April 7, 2014

Subject: Request for Focused Site Conceptual Model Addendum and Data Gap Work Plan; Fuel Leak Case No. RO0000274 and Geotracker Global ID T0600102079, Chevron #9-3322; 7225 Bancroft Avenue, Oakland, CA 94605

TECHNICAL COMMENTS

SITE AND PIPING PLAN

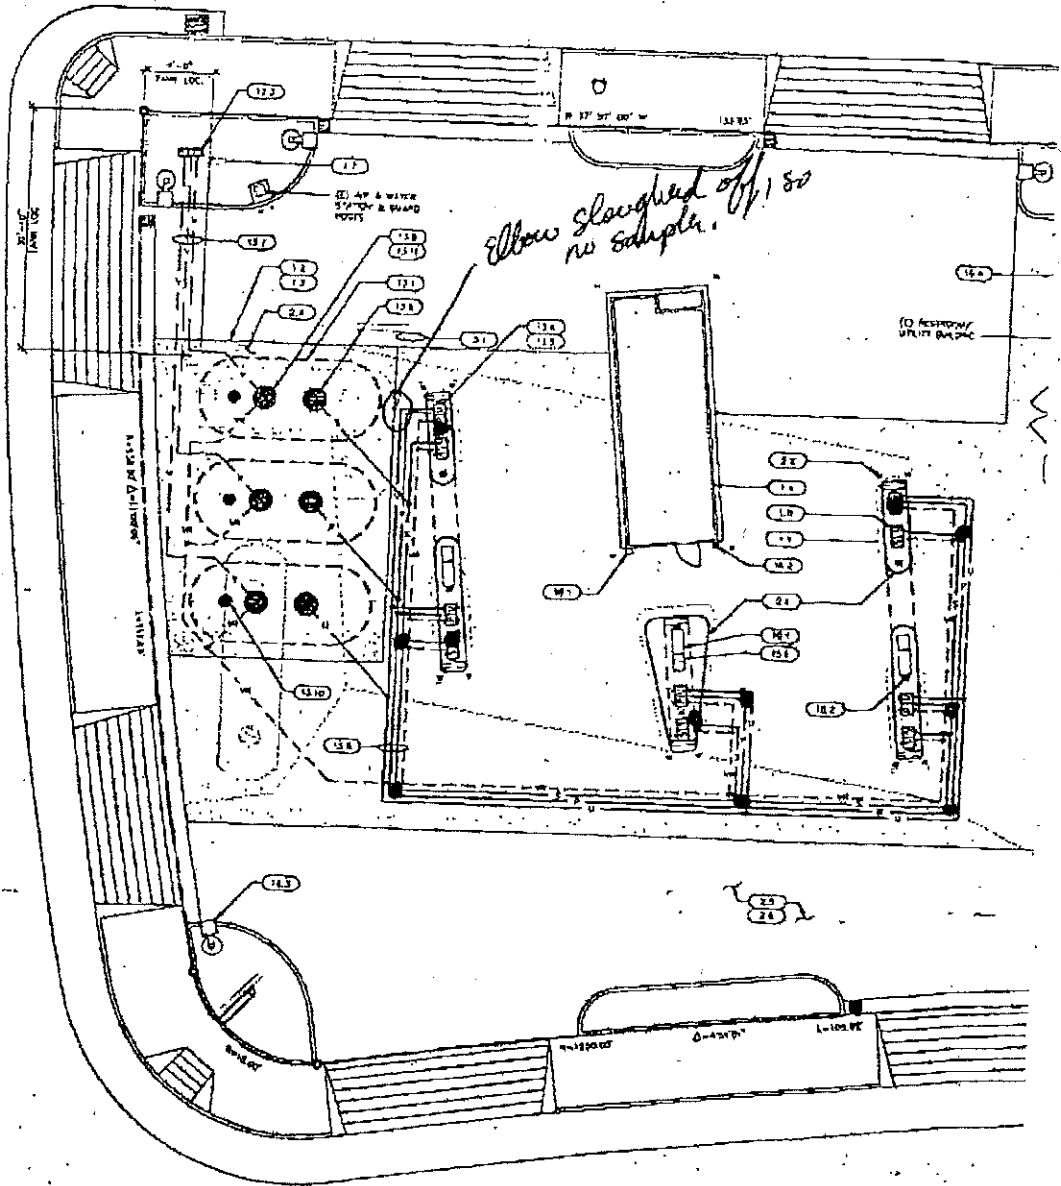
Additionally, ACEH’s files contain a facsimile copy (dated August 14, 1996) of a former site schematic that indicates that a piping “elbow sloughed off” near the southern dispensers associated with an earlier tank configuration, and that no soil sample had been collected. Two fuel releases have been

reported to be associated with the site, an earlier leaded gasoline and a reformulated gasoline containing MTBE. ACEH assumes the earlier release may be associated with this release location. This release vicinity has not been further characterized at depth. ACEH has attached a copy of the facsimile. Finally, the presence of elevated ethanol limits of detection in wells MW-1 and MW-7 indicates that a third release has occurred at the site.

Please present a strategy in the Data Gap Work Plan (described in Item 6 below) to address the items discussed above. Alternatively, please provide justification of why the site satisfies this general criterion in the focused SCM described in Item 6 below.
